August 14, 2017

California Air Resources Board
Anil Prabhu
aprabhu@arb.ca.gov
LCFSWorkshop@arb.ca.gov

Reference: **Comments on Corn Oil Biodiesel Carbon Intensity**

Figure 1. Corn Ethanol System Boundary Diagram

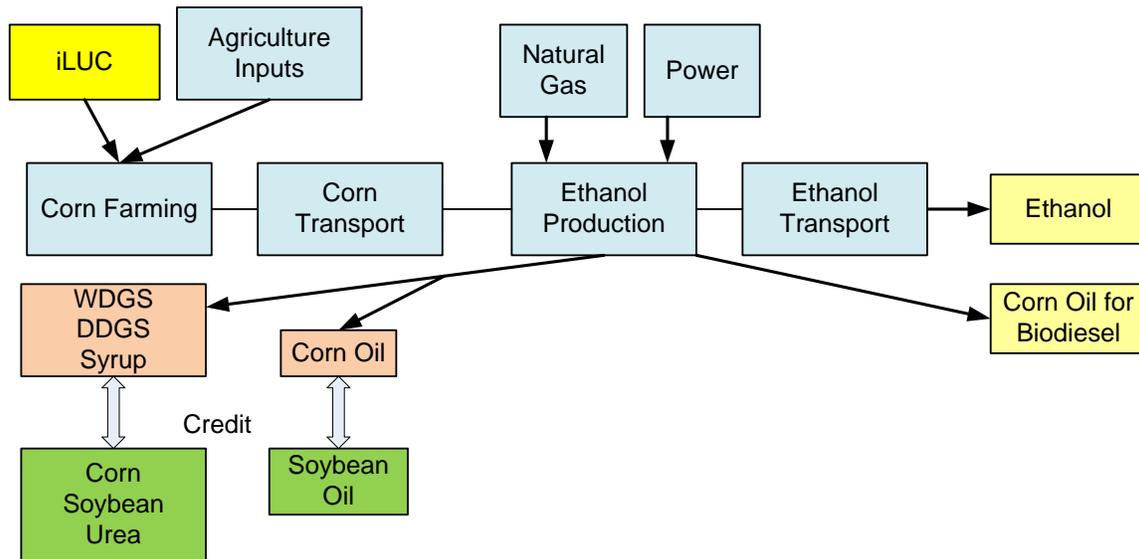
- Provide substitution credit for corn oil used as animal feed based on soy bean oil\
 - Corn oil is a substitute for soy oil in animal feed and the same upstream and ILUC emissions should be the basis for the co-product credit.
- Allocate energy inputs and emissions between ethanol and corn oil used for biodiesel based on energy content of product
 - Both ethanol and corn oil for COB are energy products and the burden of the emissions should be distributed to both products based on energy.
- Allocate ILUC to ethanol and corn oil for COB based on energy content of products
- Track carbon intensity in g/kg or g/lb of corn oil
 - Allows for GREET-type inputs for COB pathway

The current corn ethanol pathway assigns all of the corn oil (CO) production as a part of DGS and gives credit based on the same displacement ratios as DGS. CO is used in animal feed as a direct substitute for soy oil and hence should be provided with a 1:1 displacement credit for soy oil. This implies that the amount of corn oil produced will no longer be included in the DGS amount, slightly reducing the DGS credit but increasing the amount of credit for CO.

Additionally, the corn oil used for BD production should be treated like an energy product. Therefore, similar to other pathways in CA_GREET, CO, as energy co-product, should be allocated all the energy inputs and the corresponding emissions based on the energy allocation method. Per the energy allocation method, the emissions are allocated to various products proportional to the total energy content of each of the respective co-product produced. This approach also implies that the corn oil does not receive a displacement credit. The CI of this CO is also associated with it and is carried over to the BD producer who essentially buys this CO along with its associated CI burden. ARB may choose to assign an average CI value for this to every COB producers for accounting simplicity.
